Before the
Federal Communications Commission
Washington, D.C. 20554

In the Matter of)
)
Amendment of the Commission's Rules)
to Establish Part 27, the Wireless) GN Docket No. 96-228
Communications Service ("WCS"))

Opposition to Petition for Expedited Reconsideration

TECHNICAL STATEMENT OF PRIMOSPHERE LP
IN SUPPORT OF RESPONSE
TO
PETITION FOR EXPEDITED RECONSIDERATION
GN DOCKET No. 96-228

Figure 1

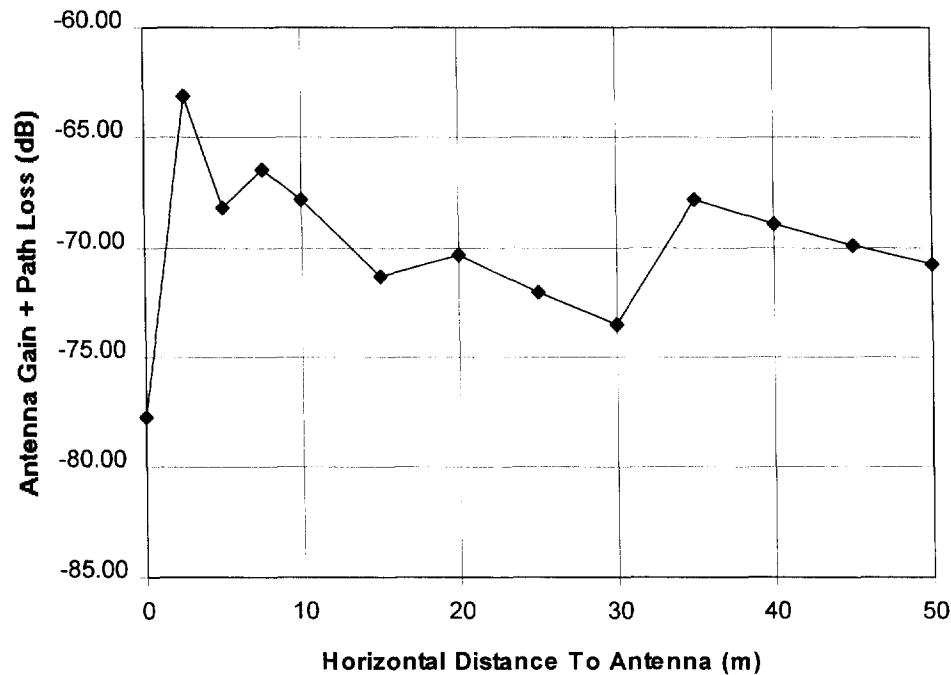
In support of use of -20 dB isolation between the PACS base station antenna and the SDARS antenna ¹¹ HNS uses as an example the mounting of the base station antenna on cables holding traffic signals. HNS goes on to assert that the maximum interference case is when the SDARS equipped vehicle is directly under the antenna. While this may be the closest the SDARS antenna gets to the PACS antenna, it is not the point of maximum interference. As an SDARS equipped vehicle approaches an intersection with a PACS antenna the path loss decreases. At the same time PACS antenna gain decreases since the SDARS receiver moves off boresight. Using the manufacturers measured antenna pattern Primosphere has graphed the PACS Antenna Gain + Path Loss vs Horizontal Distance to a PACS antenna mounted 8 m above an intersection. This graph is provided in Figure 1. The side lobes of the PACS antenna coupled with the path loss show worst case interference occurs not directly under the PACS antenna, but rather shortly before and after passing under the PACS

antenna. At this point the isolation is on the order of -12 dB not -20 dB. Further anything mounted on traffic signal support cables will be significantly affected by wind. This movement will likely change the point of maximum interference and reduce the isolation further.

There are also inconsistencies in the stated PACS base station antenna characteristics. The antenna in Table 2 of the January 30, 1997 letter from HNS is described as being a 6 dB gain stacked dipole with -20 dB isolation 90° off boresight. The February 5, 1997 letter refers to a part number for a 10 dB gain antenna with -25 dB isolation off boresight. In our analysis Primosphere assumes the January 30, 1997 description is correct since it has the characteristics used to defend the PACS link analysis.
